# NORTH TEXAS MUNICIPAL WATER DISTRICT

## LAKE SIDE INTERCEPTOR REPLACEMENT

PROJECT NO. SRWWPCF 07-1(102)

### CONFORMED SET

**PLAN AND PROFILE**  
 STA. 79+00 TO STA. 83+75.57

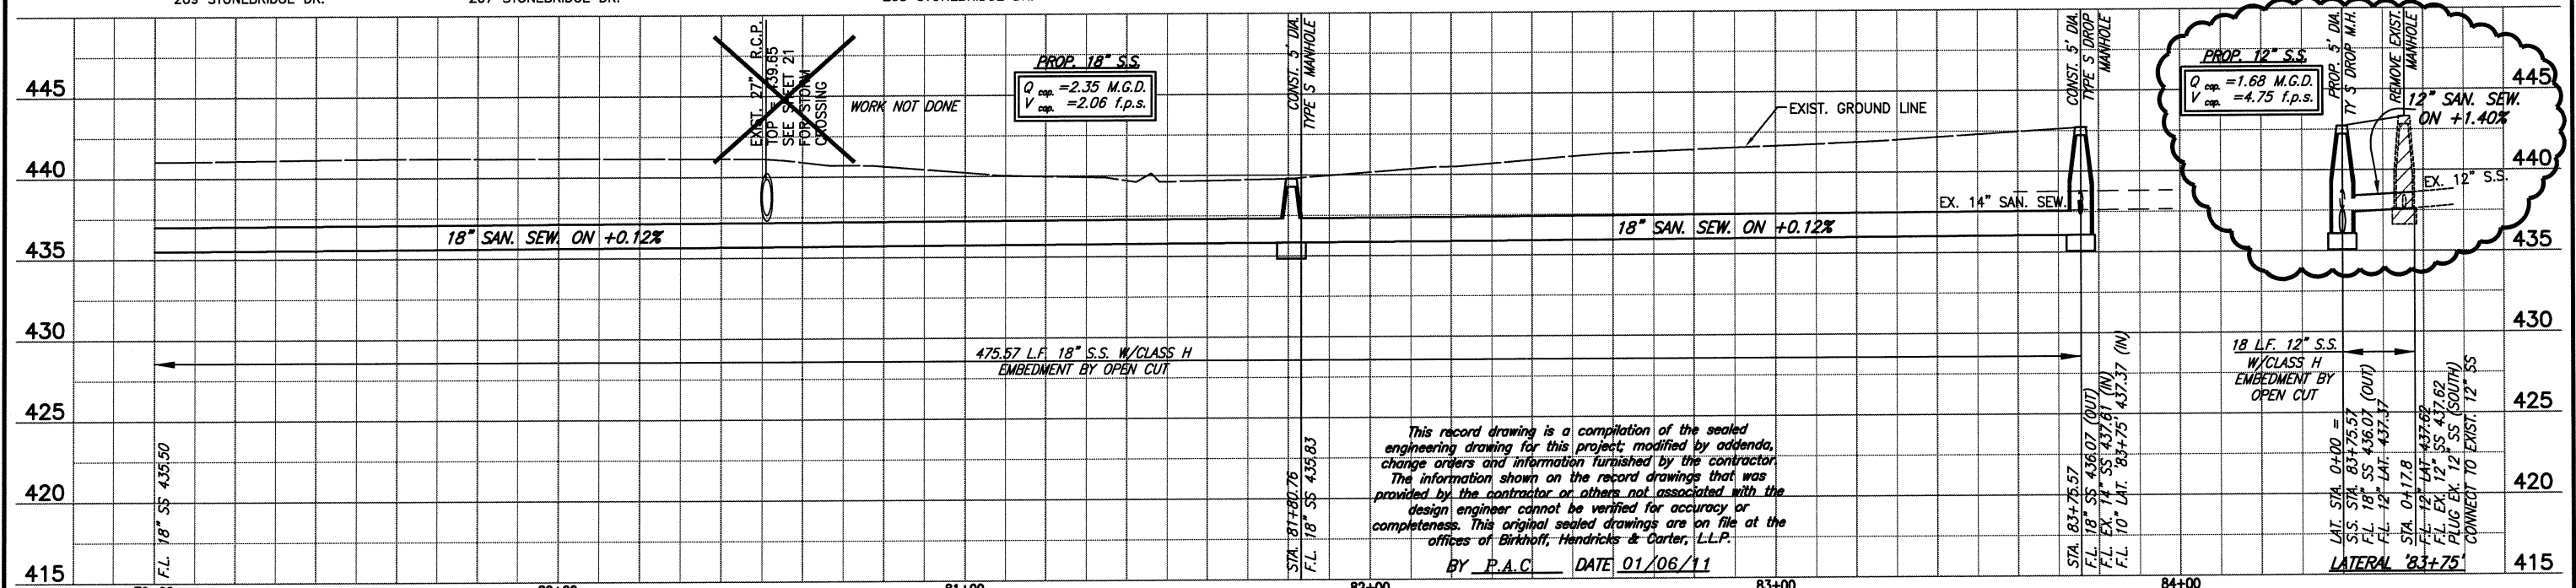
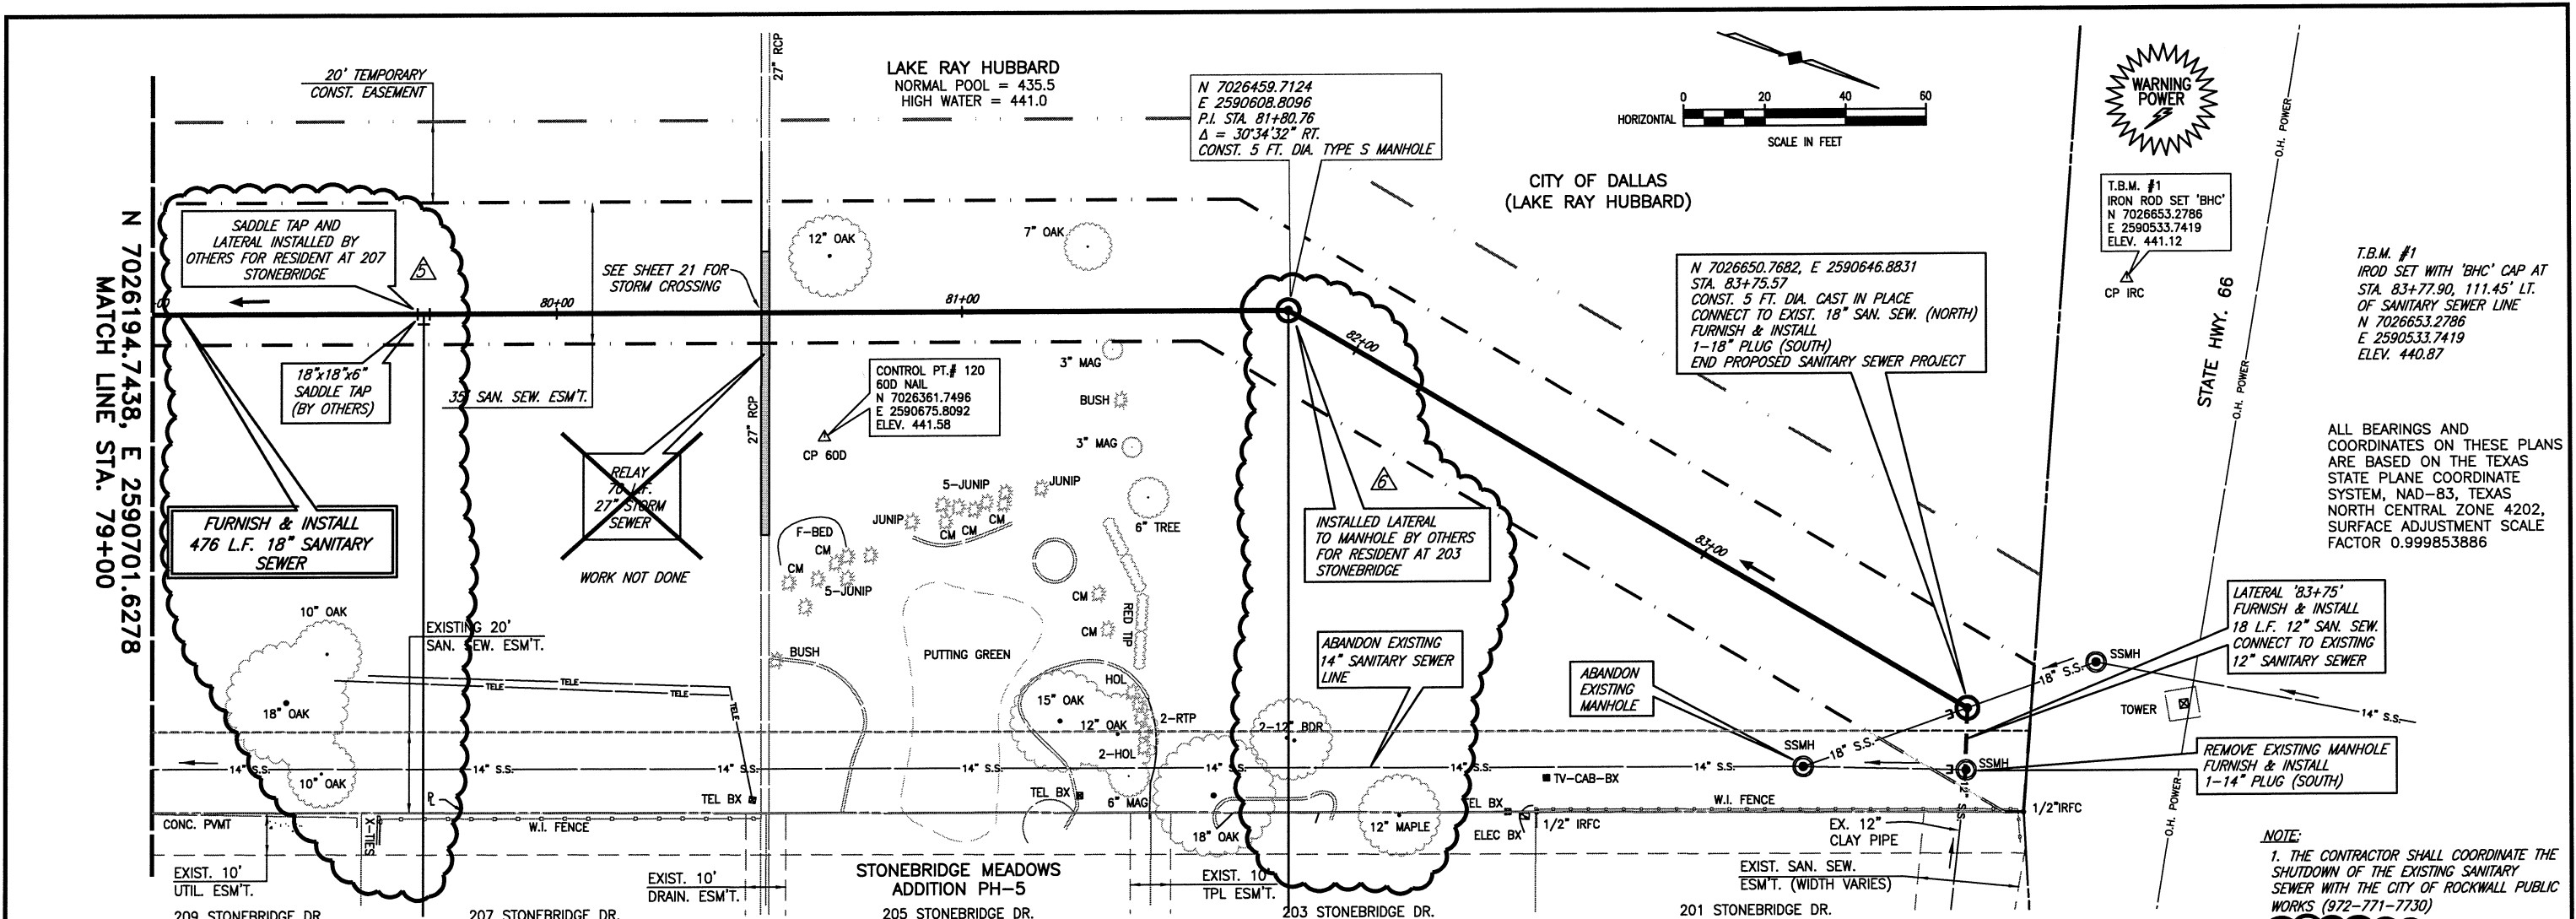
① CHANGE ORDER NO.1 2/12/09 - REVISED BORE LOCATIONS & ENCASEMENT
② FIELD CHANGE NO.4 6/29/09 - REVISED VERTICAL ALIGNMENT
③ FIELD CHANGE NO.5 11/13/09 - INSTALLED BY OTHERS
④ FIELD CHANGE NO.5 1/29/10 - INSTALLED BY OTHERS
